BVY 16-008

SUBJECT: Permanently Defueled Emergency Plan Change, Revision 0
Vermont Yankee Nuclear Power Station
Docket No. 50-271
License No. DPR-28

Vermont Yankee Nuclear Power Station
Permanently Defueled Emergency Plan Change, Revision 0
10CFR50.54(q) Screening

Title: Vermont Yankee Permanently Defueled Emergency Plan (PDEP)

Figure 4.1
Vermont Yankee Site

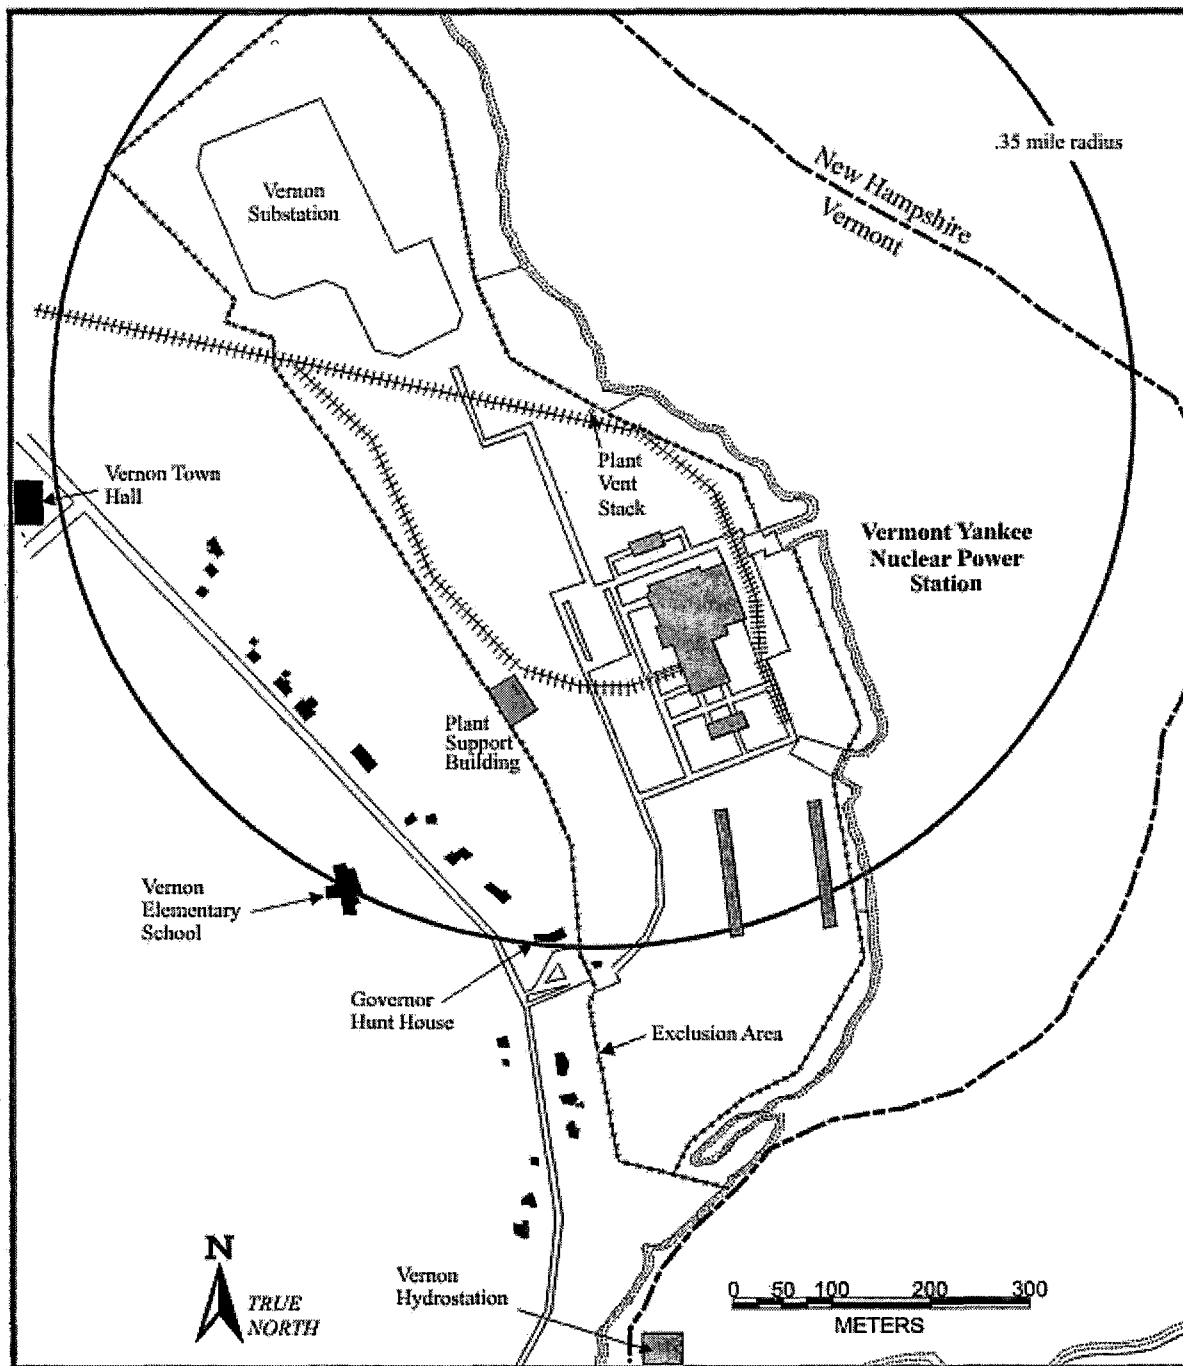
Figure 4.1, Vermont Yankee Site

- Replaced figure 4.1 with an updated figure

- Replacing Figure 4.1 with an updated figure that does not include the Power Uprate Building. The change is administrative in nature to reflect accurate facility layout. The revision does not change any facilities or equipment.
